Letter of Addendum

RE: RFP Number: RFB#26070005 Amendment No. 1
Commodity: Pre-Engineered Metal Building-NMT Drone Facility

NMT DRONE FACILITY PHASE 1

SHEET NAME:
DOOR SCHEDULE, WINDOW SCHEDULE +
DETAILS

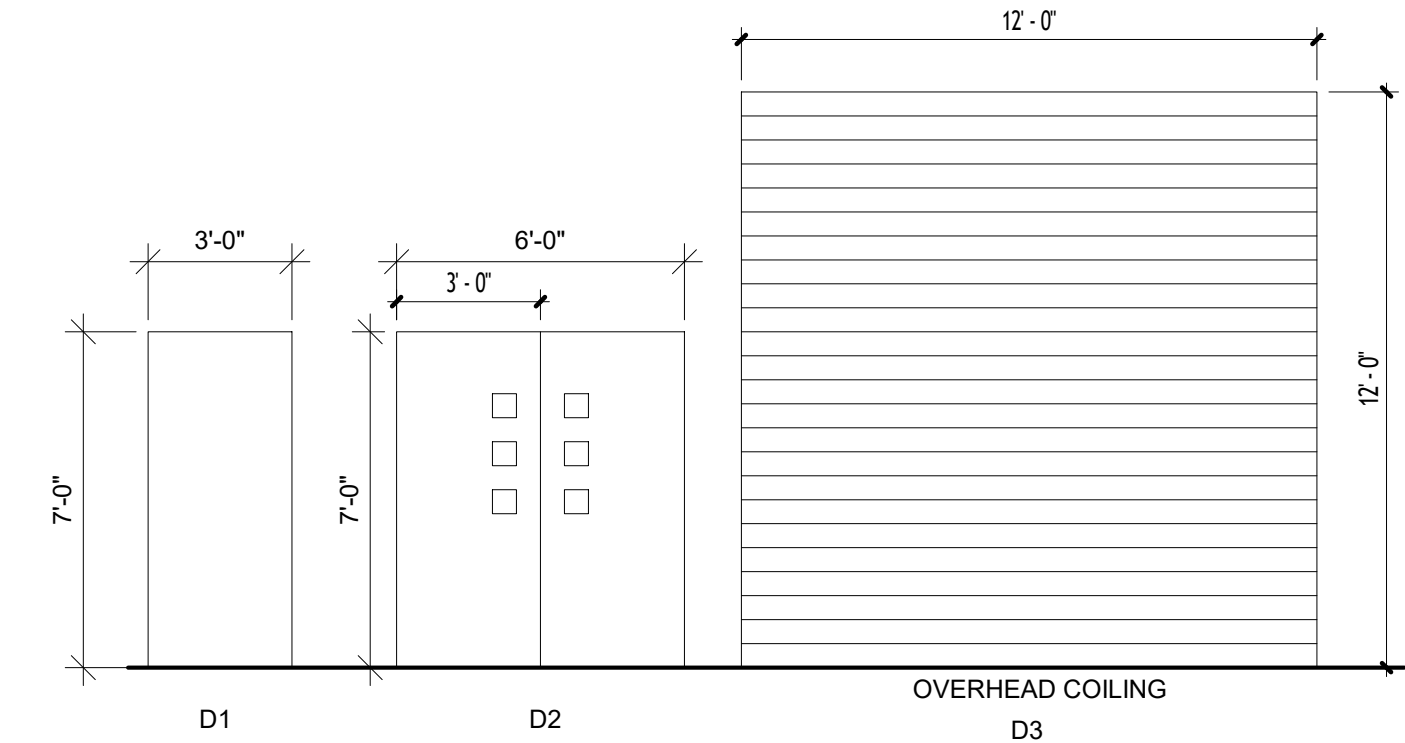
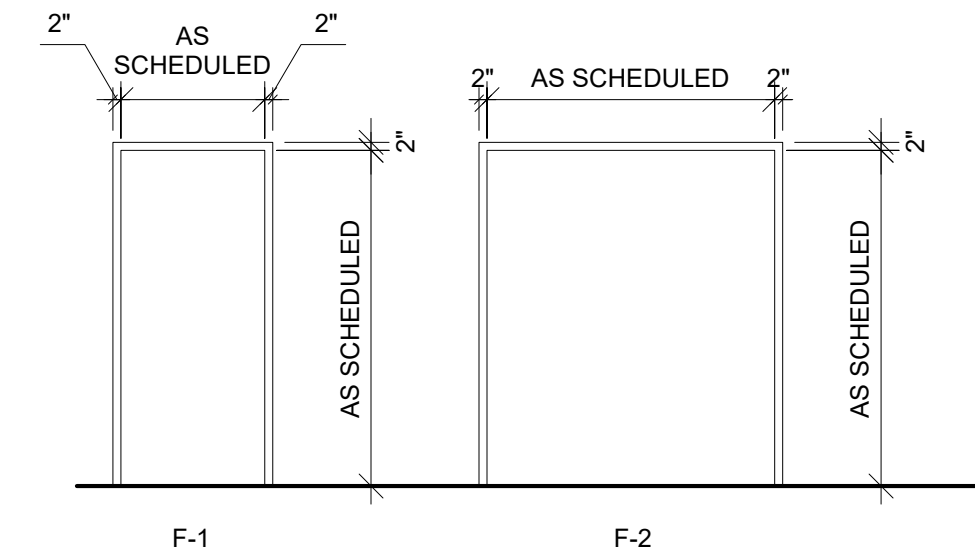
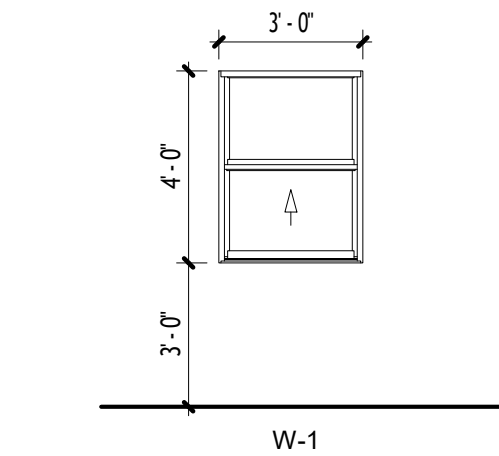
- Q6) Is insulation required?
A6) Yes, per RFB document.
- Q7) Window schedule and door schedule are not legible on the documents. Can you please provide a clearer set of drawings?
A7) Please see attached PDF document.
